MEMORANDUM

Subject: Festival Industrial Development (PZ25-12000024)
2900 West Sample Road
Minimum Driveway Stacking Lane Distance Variance Request Review
WA_PLAN_2025-#003

The purpose of this memorandum is to summarize our review of a requested variance from City of Pompano' Zoning Code related to Minimum Stacking Lane Distance for Parking Lot Entrance Driveways (City Code Table 155-5101.G.8.B) for the Festival Industrial Development project (PZ25-12000024). The following sections summarize our review of the request.

OVERALL SITE PLAN

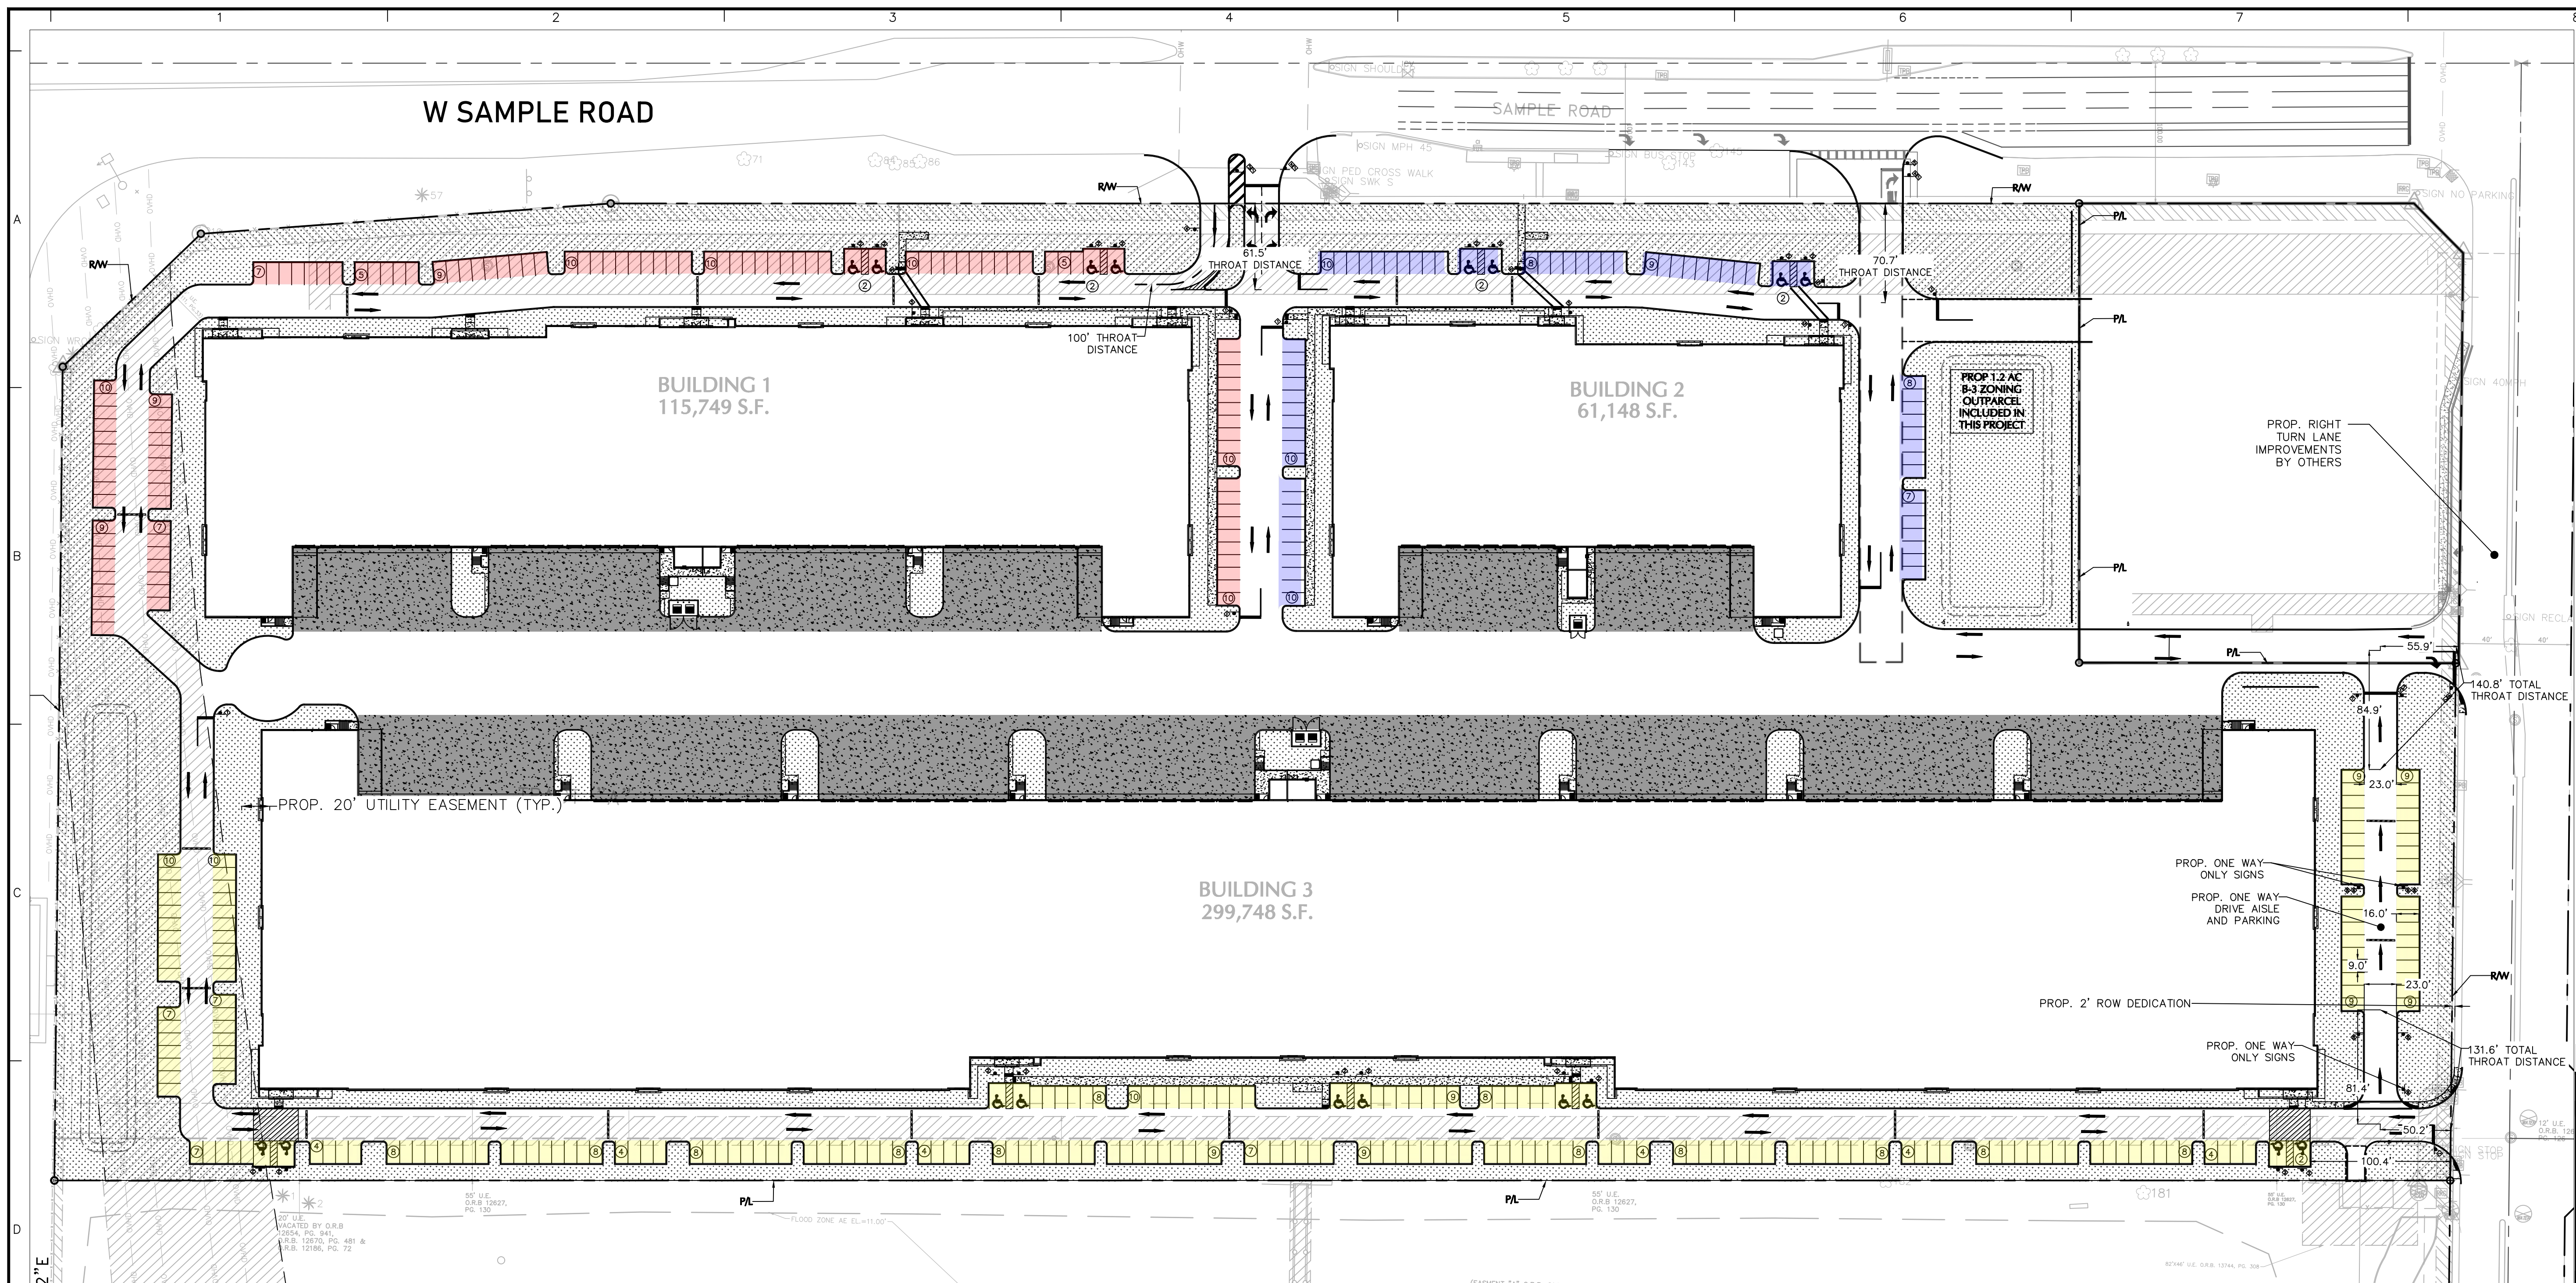
- Driveway 1 (Ingress) provides 100 feet of driveway length for the ingress lane:
 - o The MAMH does not provide specific criteria for entering driveway lengths but does state that driveway lengths are not applicable to all entrances. However, the applicant did provide conceptual approval from FDOT that specified a required driveway length of 100 feet which is provided on the site plan.
 - o The proposed driveway length exceeds the 75 feet recommended in NCHRP.
 - o Based upon the applicant's traffic volume assignment, this driveway is considered a minor driveway based upon the peak hour right-turning volumes which would require a minimum driveway length of 25 feet. Note that minor driveways are not typically signalized. However, because it is located at a signalized driveway, additional driveway length beyond 25 feet should be considered and is being provided.

- Driveway 1 (Egress) provides approximately 60 feet of driveway length for the egress lane with two (2) exit lanes:
 - o The MAMH does not provide specific criteria for exiting driveway lengths but does state that driveway lengths are not applicable to all entrances. However, the applicant did provide conceptual approval from FDOT for the site plan that proposes a 60-foot egress driveway length. Note that given that this driveway's entry lane does not conflict with the exit lanes for the site and the internal site intersection is proposed as all-way stop control, there is no potential for vehicles entering to conflict with queues from exiting vehicles. Therefore, given the site configuration, the driveway length of less than 100 feet is not a concern.

- Driveway 2 provides approximately 70 feet of driveway length:
 - o The MAMH does not provide specific criteria for entering driveway lengths but does state that driveway lengths are not applicable to all entrances. However, the applicant did provide conceptual approval from FDOT that required a minimum driveway length of 50 feet which is provided on the site plan.
 - o The proposed driveway length exceeds the 50 feet recommended in NCHRP.
 - o Based upon the applicant's traffic volume assignment, this driveway is considered a major driveway based upon the total peak hour volume which would require a minimum driveway length of 100 feet.

- Driveway 3 provides approximately 56 feet of driveway length:
 - o The MAMH does not provide specific criteria for entering driveway lengths but does state that driveway lengths are not applicable to all entrances.
 - o The proposed driveway length exceeds the 50 feet recommended in NCHRP.
 - o Based upon the applicant's traffic volume assignment, this driveway is considered an intermediate driveway based upon the total driveway peak hour volumes which would require a minimum driveway length of 50 feet.

- Driveway 4 provides approximately 50 feet of driveway length:
 - o The MAMH does not provide specific criteria for exiting driveway lengths but does state that driveway lengths are not applicable to all entrances.
 - o The proposed driveway length meets the 50 feet recommended in NCHRP.
 - o Based upon the applicant's traffic volume assignment, this driveway is considered a minor driveway based upon the total peak hour intersection volume which would require a minimum driveway length of 25 feet which is exceeded on the proposed site plan.

Given that the ingress configuration of Driveway 1 is under the jurisdiction of FDOT, FDOT has conceptually approved the site plan/driveway length, and the driveway length meets the guidance identified in our document review, we take no exception with the proposed configuration.

Given that egress configuration of Driveway 1 is under the jurisdiction of FDOT, FDOT has conceptually approved the site plan/driveway length, and the driveway length generally meets the guidance identified in our document review, we take no exception with the proposed configuration.

Although Driveway 2 is under the jurisdiction of FDOT and they have conceptually approved the site plan/driveway length, it is recognized that this driveway serves both the proposed industrial development and the adjacent gas station with convenience market (east) as well as being considered a major driveway based on BCC criteria. Therefore, it is recommended that to restrict the eastbound movement along the interior drive aisle to right-turn only to reduce potential conflicts that could result in queues extending into the public right-of-way along SR 834/West Sample Road.
